ARCHITECTURAL REVIEW BOARD MEETING

JANUARY 10, 2023 IN THE CITY COUNCIL CONFERENCE ROOM AT 5:00 PM

PLANNING AND ZONING COMMISSION CASE MEMO

TO: Planning and Zoning Commission
DATE: January 10, 2023
APPLICANT: Bowen Hendrix; *DuWest Realty, LLC*
CASE NUMBER: SP2022-057; *Site Plan for a Chipotle*

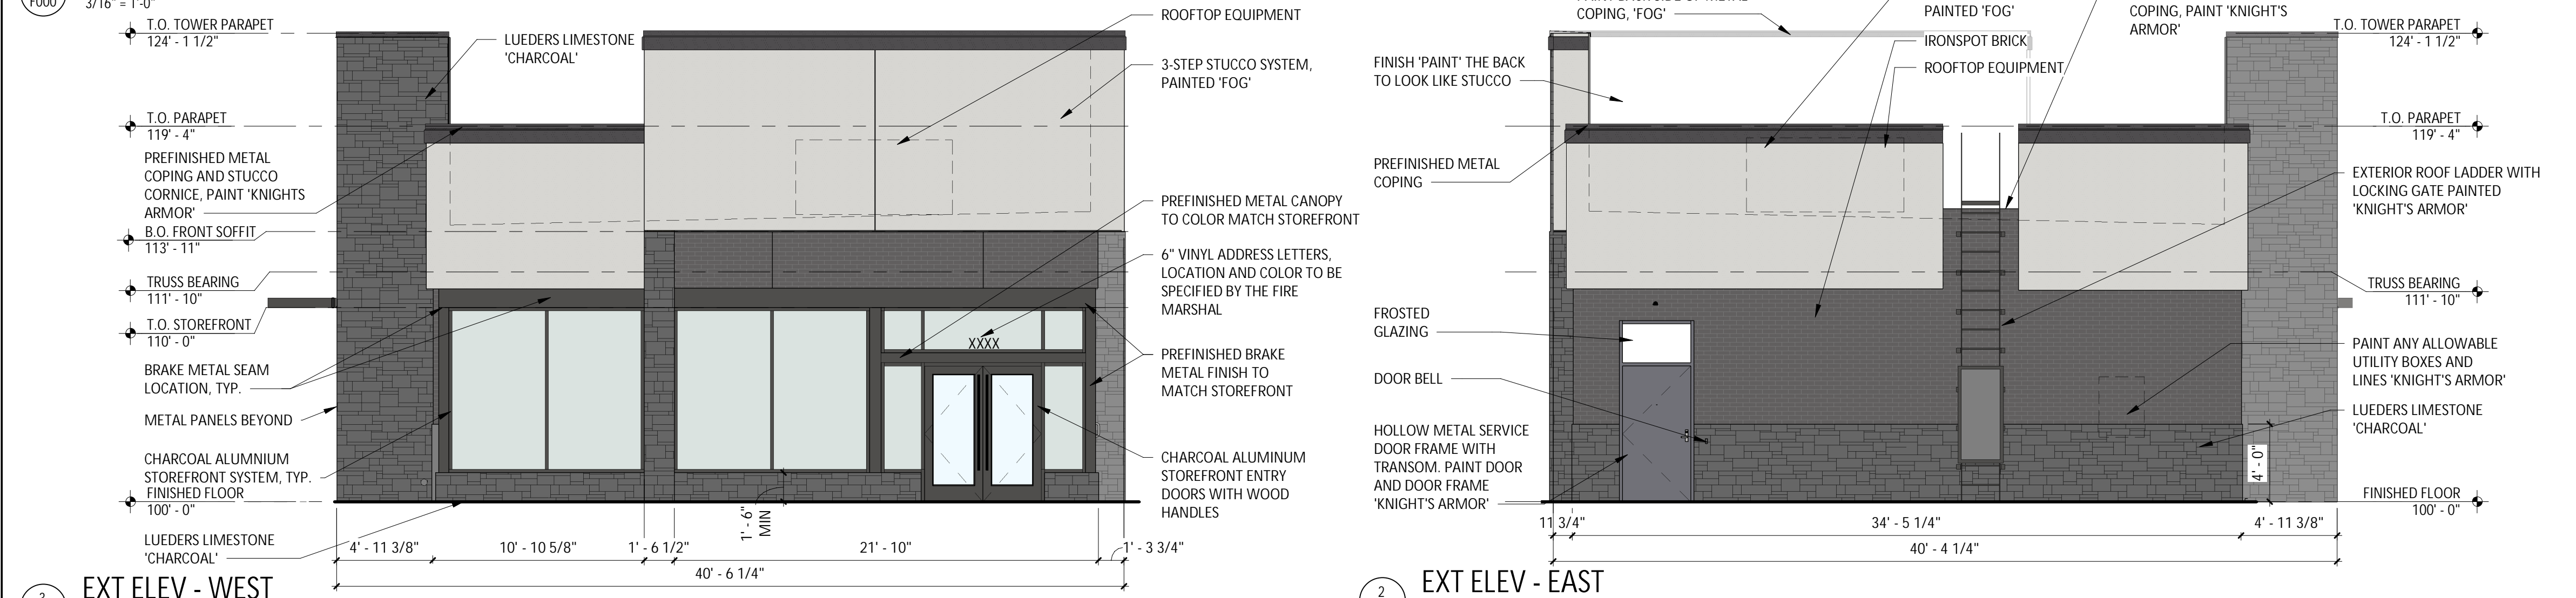
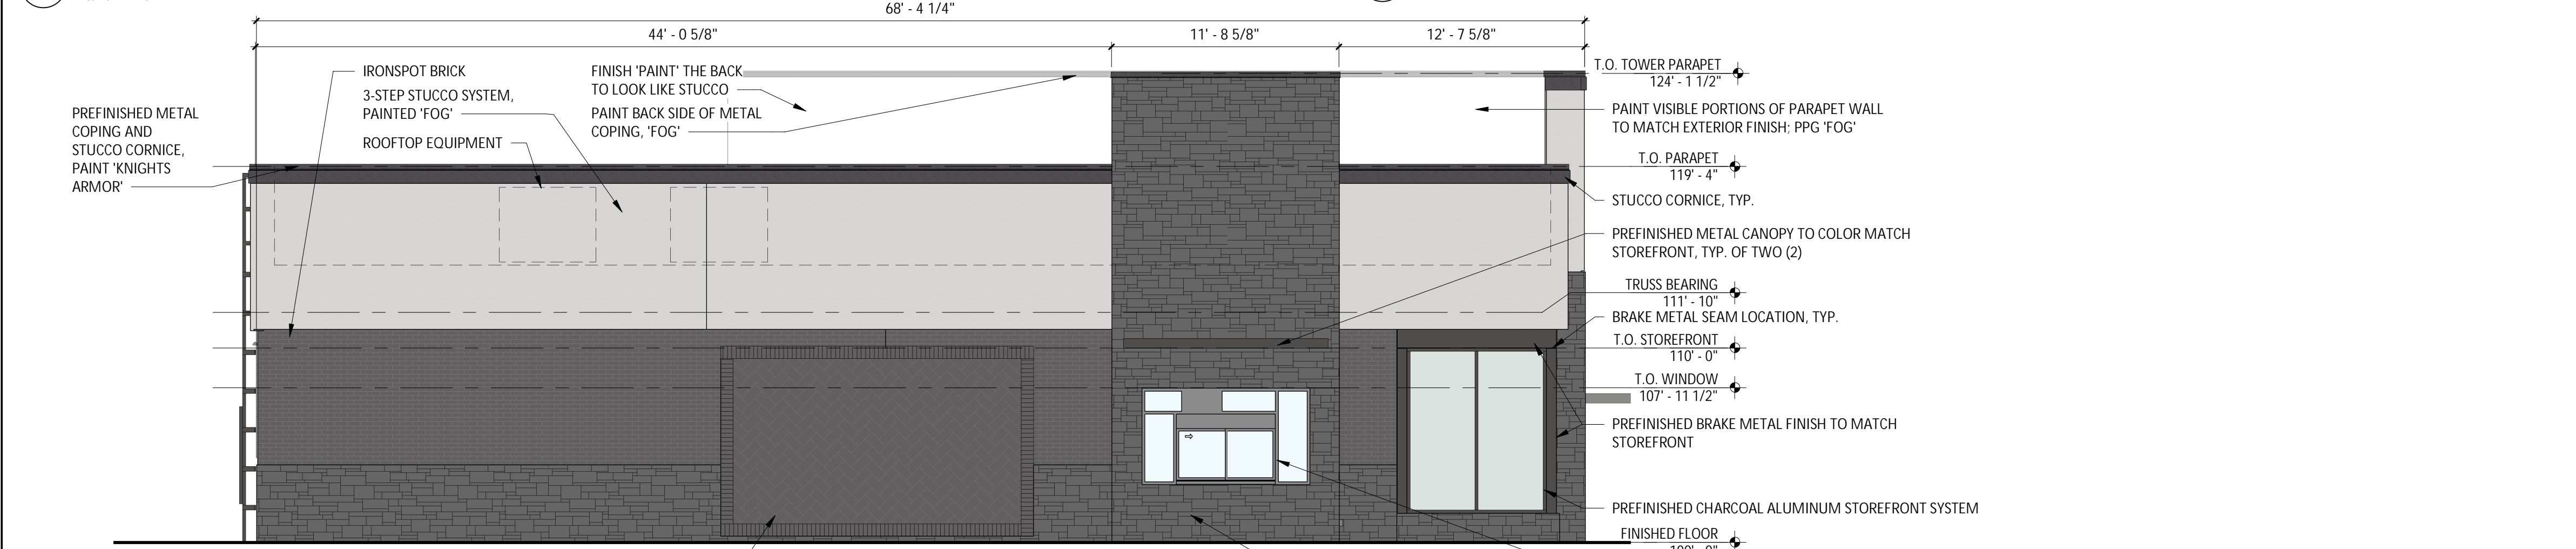
parapet to screen the roof mounted utility equipment. This will require a variance from the Planning and Zoning Commission pending a recommendation from the Architectural Review Board (ARB).

The Architectural Review Board (ARB) reviewed the building elevations provided by the applicant on December 27, 2022, and made the recommendation to the applicant that they finish both sides of the parapet and increase the vertical articulation elements. The ARB will re-review the building elevations at their meeting on January 10, 2023 and provide a recommendation to the Planning and Zoning Commission prior to the Planning and Zoning Commission taking action on this case.

- (2) Before any Certificates of Occupancy (CO's) are issued for future tenants, documentation shall be provided indicating that any proposed *Roof Top Units (RTU's)* will meet the screening requirements and will not be visible from any adjacent property, open space, or public right-of-way.
- (3) Any construction resulting from the approval of this Site Plan shall conform to the requirements set forth by the Unified Development Code (UDC), the International Building Code (IBC), the Rockwall Municipal Code of Ordinances, city adopted engineering and fire codes and with all other applicable regulatory requirements administered and/or enforced by the state and federal government.
